Status of the Polarized Target Vacuum Can

- Design of OVC for **SANE**, **Semi-SANE**, and **Wide-Angle Compton Scattering (WACS)** Experiments

Changes to the Can Design (1)

Vacuum port design

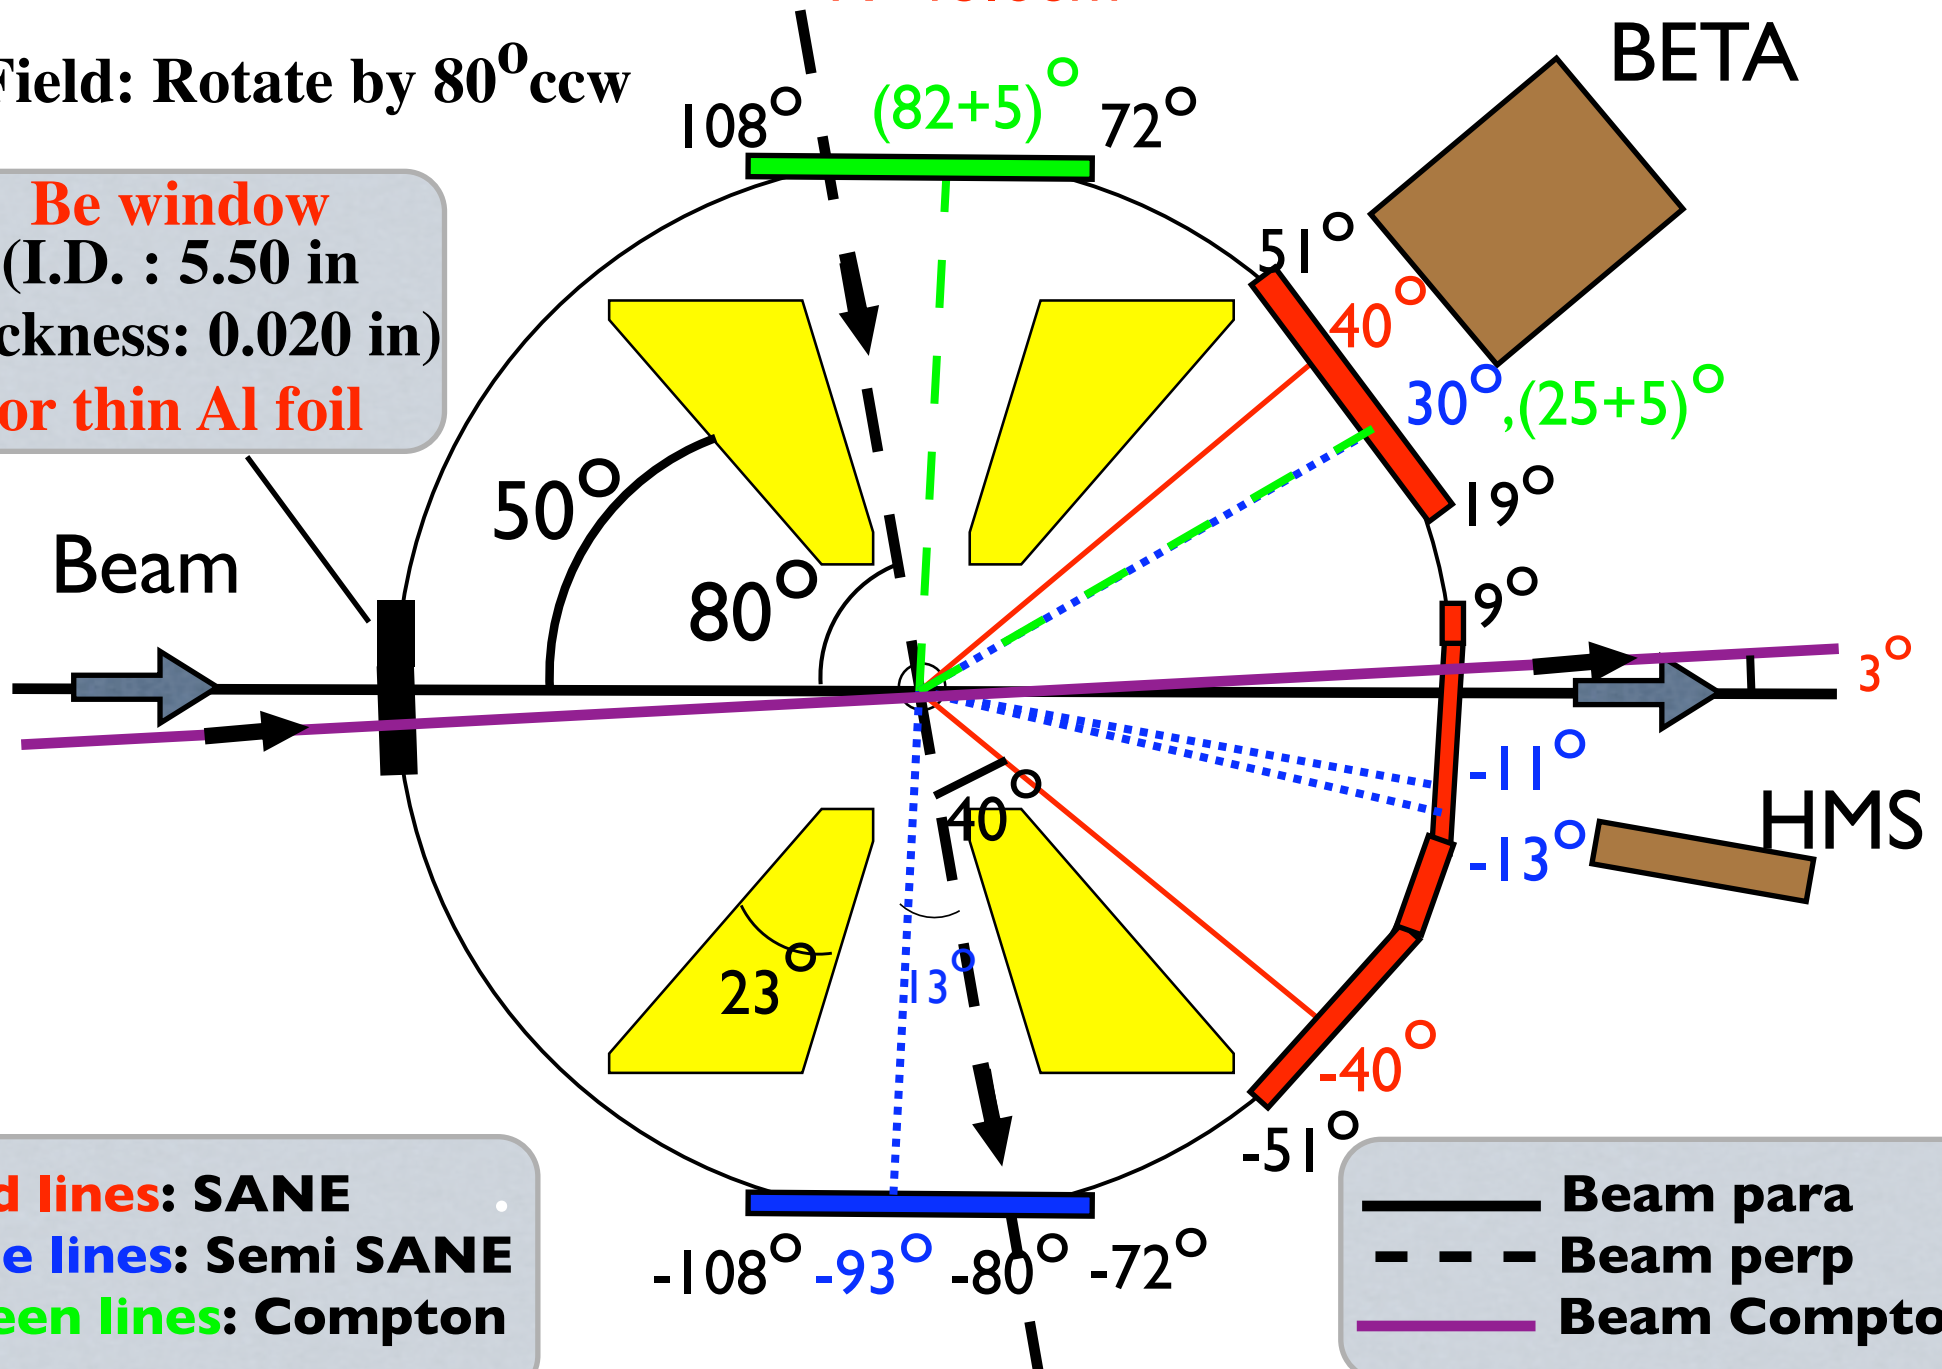
- AFTER the design was submitted for bidding, we noticed that the vacuum port in the design was ISO-63 (2.8in diameter), which was not what we requested (ISO-100, ~4in diameter)
- This error was already corrected and design has been re-submitted to the companies for bidding. After the bidding is finished, a vendor will make the can with the vacuum ports (I was initially told that JLab would make the vacuum ports).

OVC Window locations and dimensions

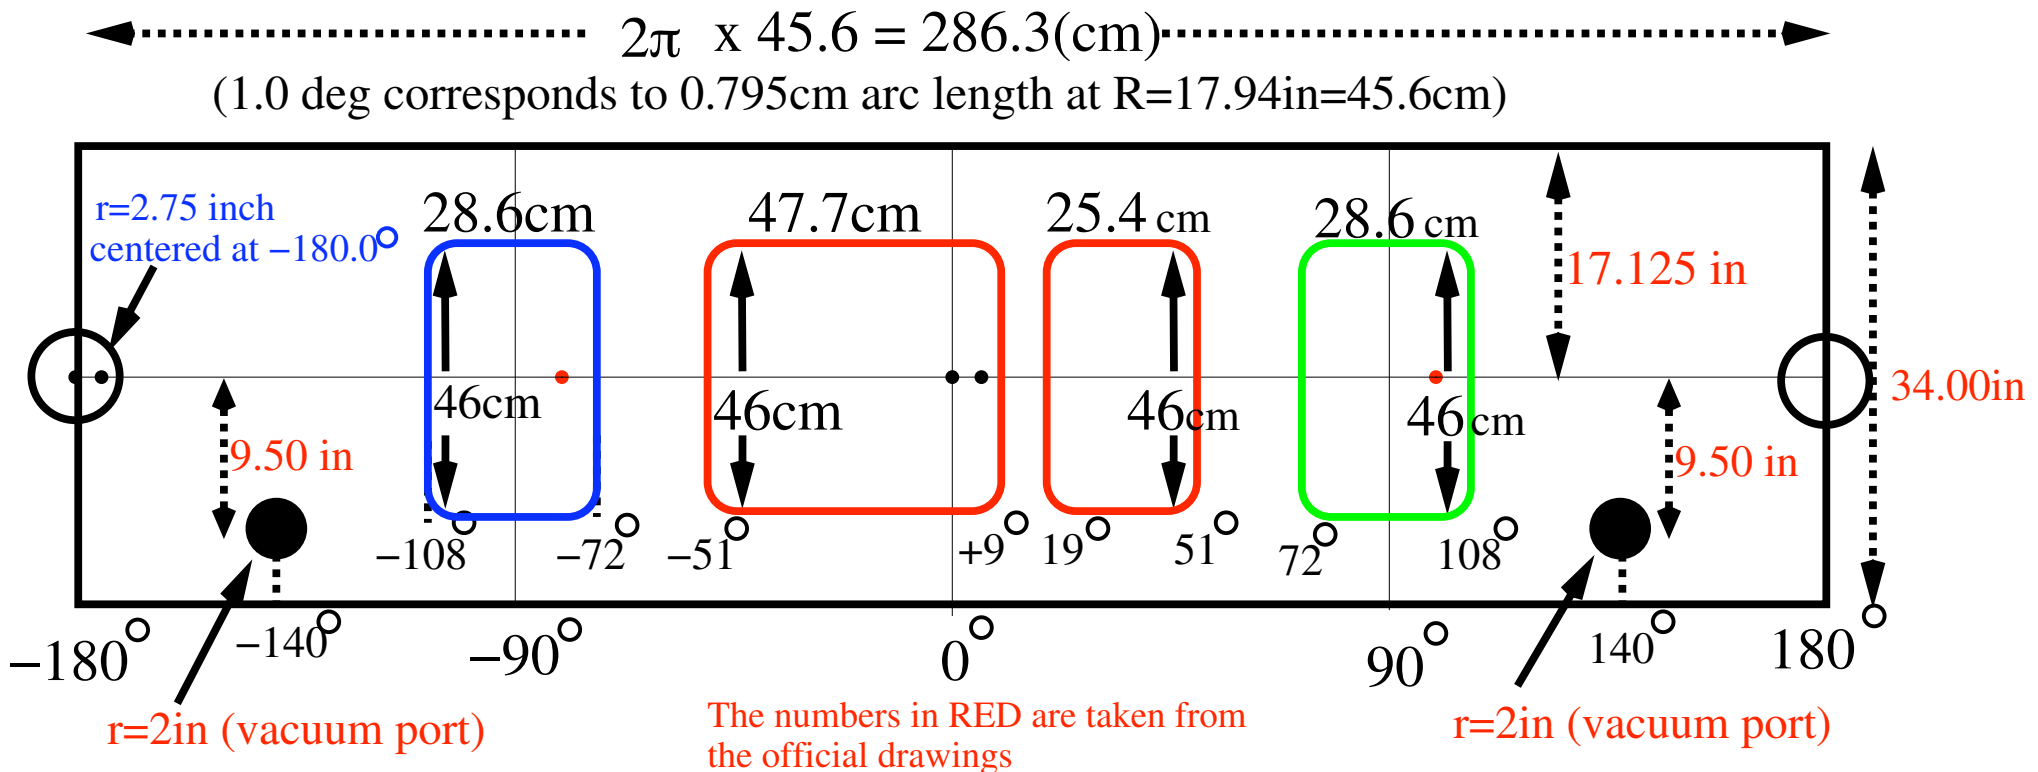
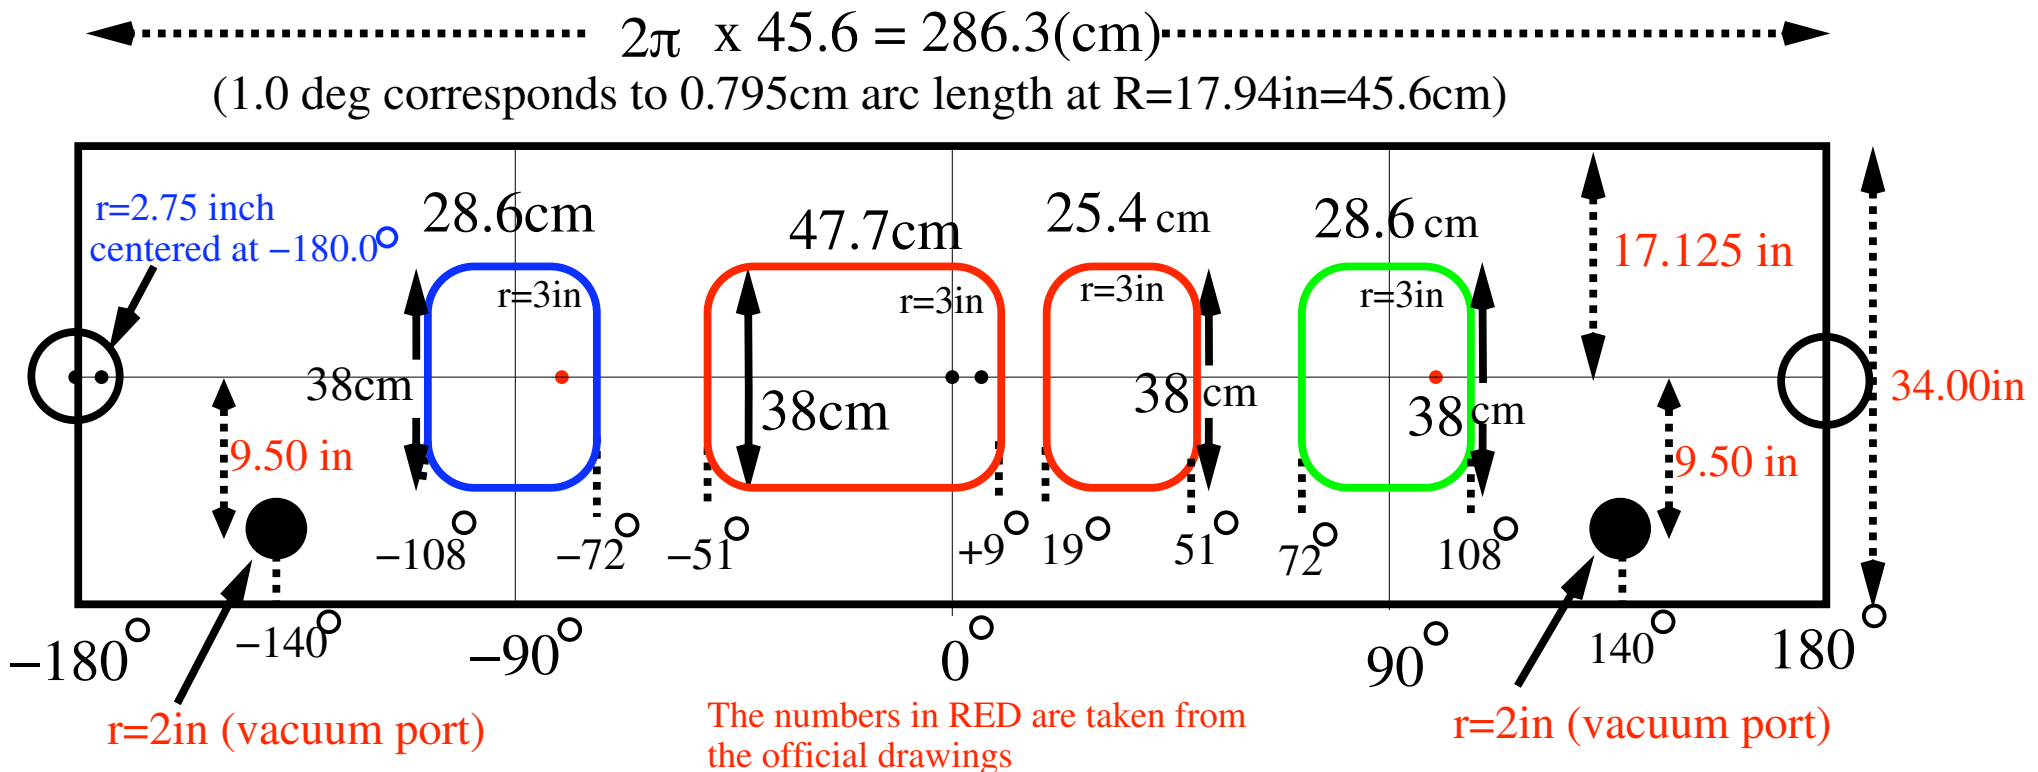
- We were informed by the engineers that the original window height of 46cm would not meet the JLab safety requirements, and suggested that it be **reduced to 15in (38cm)**. The radius of curvature at the corners is **3in**.
- The window thickness is **20mil (+/- 1mil)**
- According to my simulation results, SANE/Semi-sane needs at least 33cm height, so this reduced height should be fine.
- Because this will limit the vertical acceptance, the BigCal for WACS will be placed at 2.8m (was 2.5m) from the target. Furthermore, they would need to rotate the can by 3° **clockwise instead of 5°** (if they decide to rotate it to obtain better acceptance).

- Roll-out view of the OVC with the inner radius of **45.6 cm**.
- The window height reduced to **15in (38cm)** from 46cm.
- The total acceptance loss from the round corners of **3in** radius is **1% (2%)** for SANE/SemiSANE (WACS)

Nitrogen Shield Window locations and dimensions (Final design)

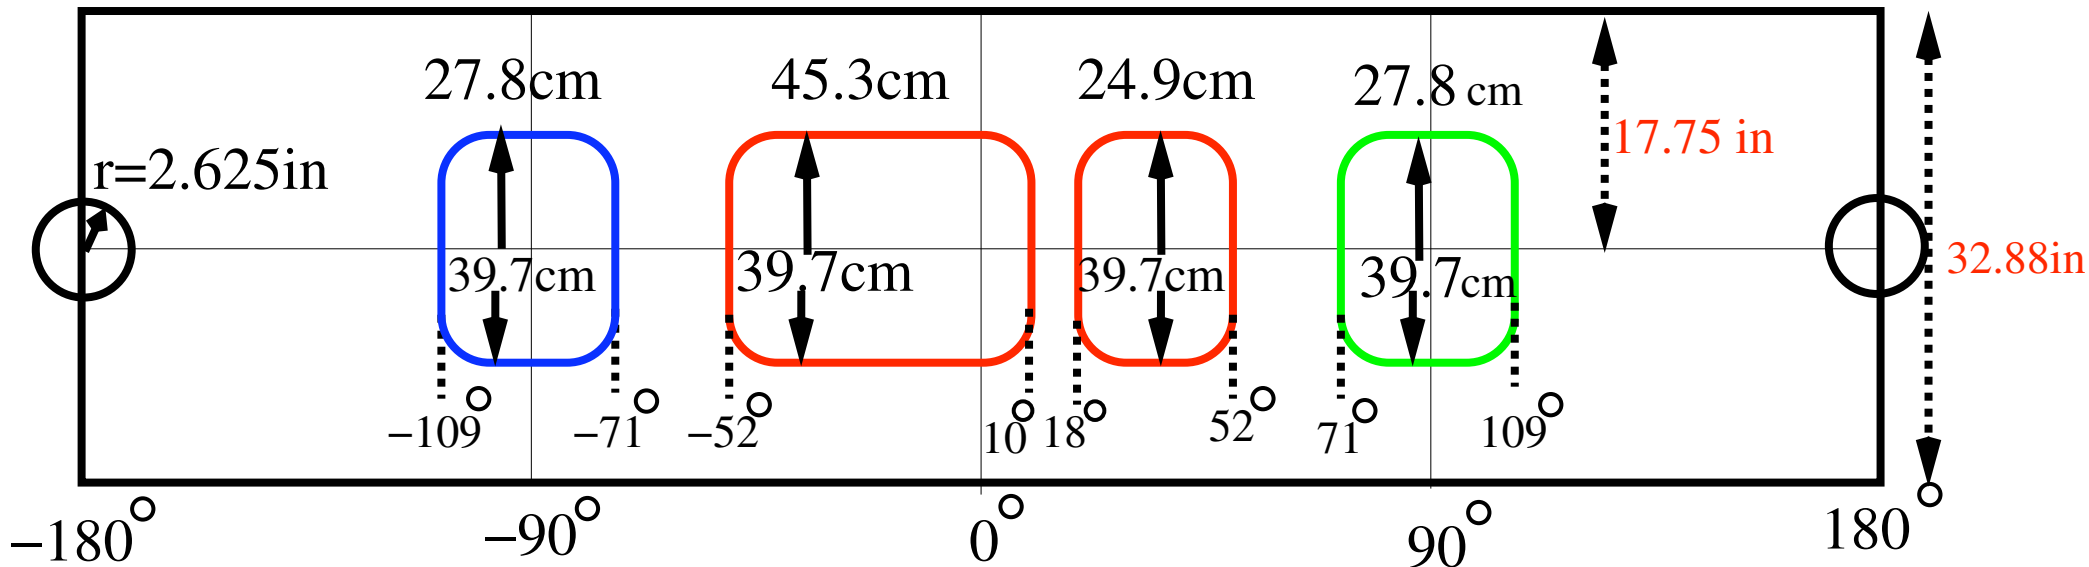
- The SANE NS design was reviewed by Don Crabb and me in January. We noticed that the I.D. of the SANE NS may be bit too small (it was 41.0cm then). The existing Gen and Oxford NS have I.D.s of 41.5cm and 41.6cm, respectively.
- Thickness of nitrogen shield is reduced to 3/16 in (from 1/4 in) so that the SANE NS has I.D. of 41.5cm, very close to the old NS.
